Permit Type	Permit Number	Opened Date
Building/Residential/Misc/Tanks	B20003134	09/17/2020
Description of Work		
SFD/ INSTALL (1) 1,000 GALLON UNDERGROUND PROPANE TANK

From: Oswald, Hank
Sent: Friday, September 18, 2020 9:49 AM
To: 'MICHELLE@APPLIEDANDAPPROVED.COM'
Subject: B20003134_12241 Mayapple Drive_UP Tank

LOT 32 BUILDING PERMIT PLOT PLAN

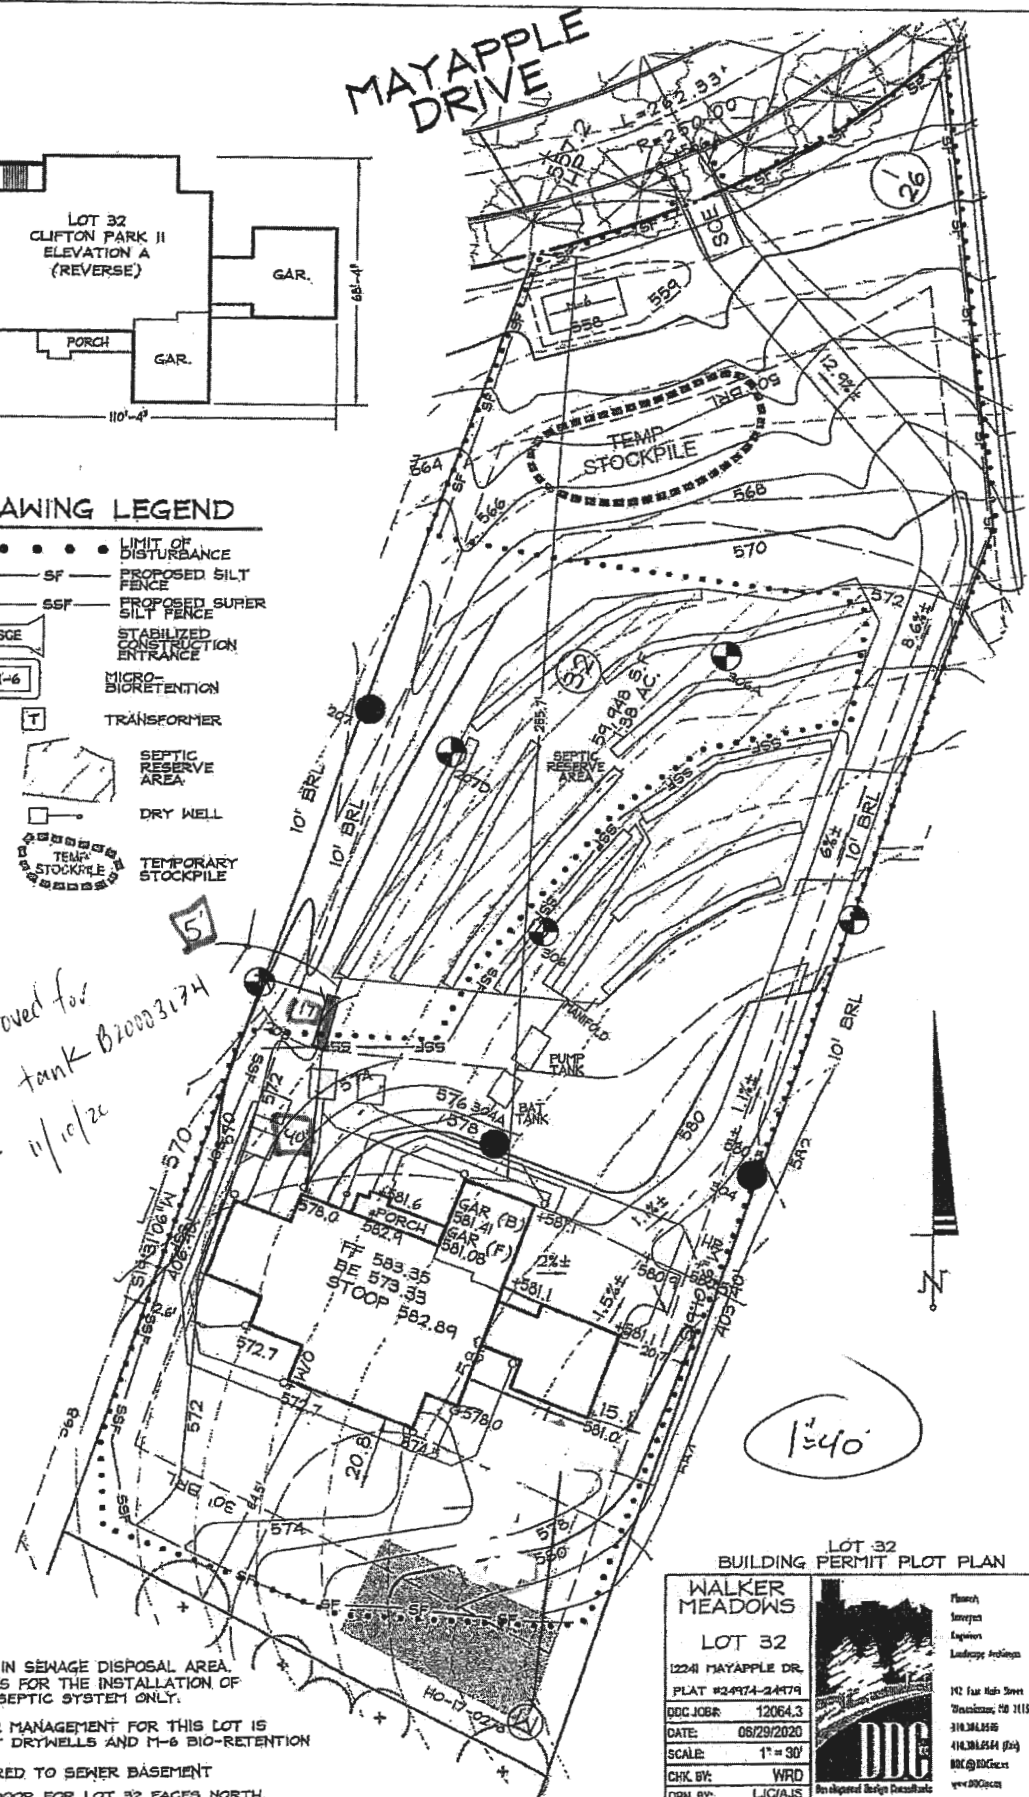
+ Placed on hold 9/18/20 until septic sys. has been installed & septic plan reviewed. - H.O.

This tank permit (B20003134) is being placed on hold until the septic system has been installed. Please note, the proposed location of the U.P. Tank is located too close to the well box. Every effort must be made to meet the 100 foot setback. Once the septic system has been installed, please make sure the well and septic components are accurately shown on the plan.

Approved 11/10/20

Approved for
 LP tank B20003174
 RBT 11/10/20
